## Product Change Notification / NTDO-14VTWR800

CCB 4395.001 Final Notice: Qualification of MMT as additional assembly site for selected Micrel SY5805xAUMG, SY880x3LMG, SY880x3CLMG and SY88xxxALMG device families available in 16L VQFN (3x3x1.00mm) package.

**CCB 4395.001**  
**Pre and Post Change Summary**  
**PCN # NTDO-14VTWR800**

**PCN#: NTDO-14VTWR800**

## Pre Change UNIS

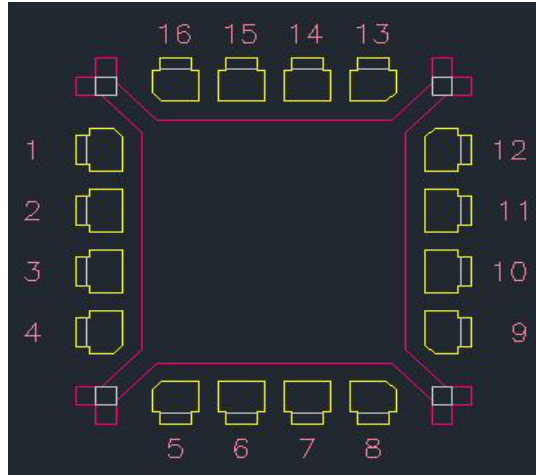
<b>Lead frame Material</b>	C194
<b>Lead frame DAP surface prep</b>	NiPdAu
<b>Lead frame lead-lock</b>	None

## Post Change MMT

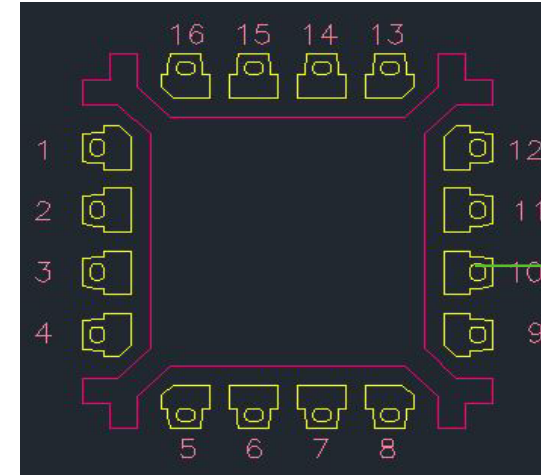
<b>Lead frame Material</b>	C194
<b>Lead frame DAP surface prep</b>	NiPdAu
<b>Lead frame lead-lock</b>	Yes

Note: The lead lock hole fills with mold compound during the assembly process and provides improved protection against moisture penetration around the interface edges between pins and mold compound.
